Re: EIS CBD and South east light rail project

I refer to the EIS supporting document dated June 2013 and propose the following modifications for your consideration. These proposals do not change the proposed George St line but to add a city circle line to improve the current proposal. The proposed modification to the south east line is to use Albion rather than Devonshire Street to connect to Anzac Parade

Figure 1.1 Existing and proposed light rail in Sydney (CSELR shown in blue)

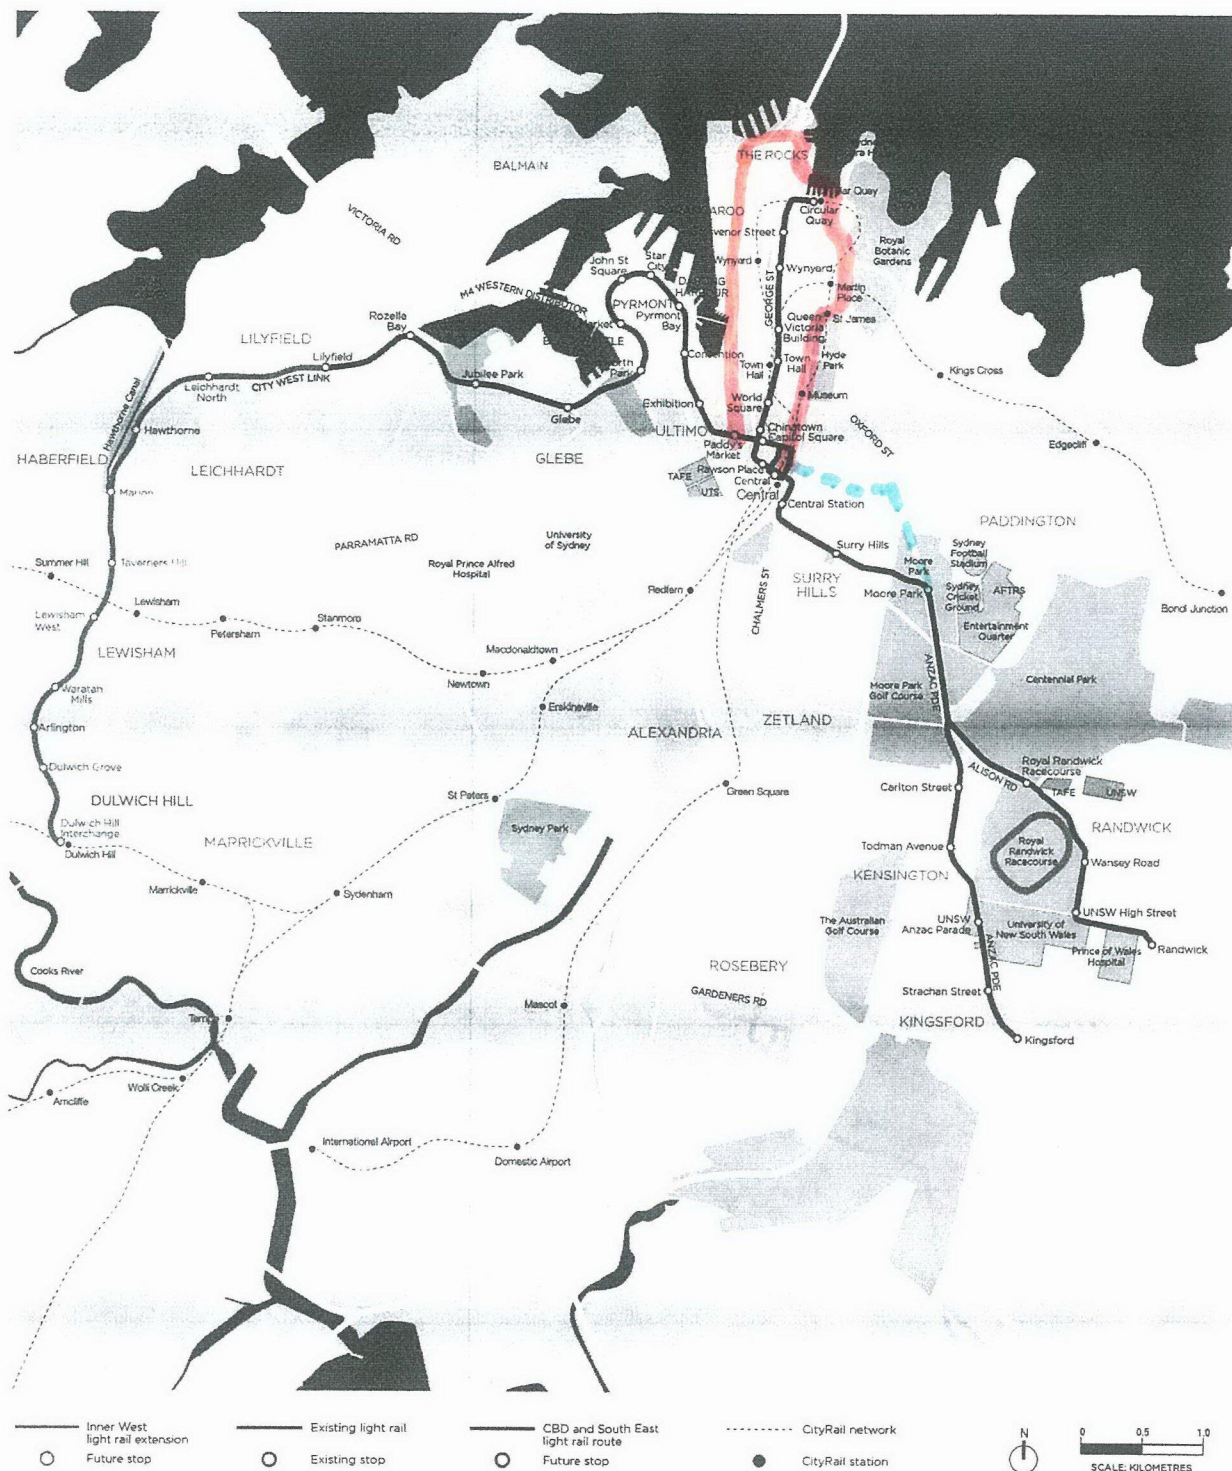
Extend the light rail service from Central Station to the extremities of the city centre area, connecting nearly all of Sydney's major tourist attractions, most major car parks, heavy rail stations and all major bus and ferry routes out of the city. The proposed route uses the following existing road systems and traffic free spaces.

- Central Station east ramp to Hay Street east to Elizabeth Street
- North along Elizabeth east to Macquarie Street via St James Road
- Macquarie Street north to Bent Street then to Circular Quay via Philip Street
- Circular Quay west via Alfred Street to George Street
- George Street north via The Rocks to Dawes Point and Hickson Road
- Hickson Road through Walsh Bay to Barangaroo
- Barangaroo south via Sussex Street to Haymarket
- Haymarket branch connects to existing Central station line

Extend the Hay Street service to Elizabeth Street and connect to Anzac Parade via Albion and Flinders Streets. This alternative route would reduce construction cost and maintain access for Surry Hill's residents.
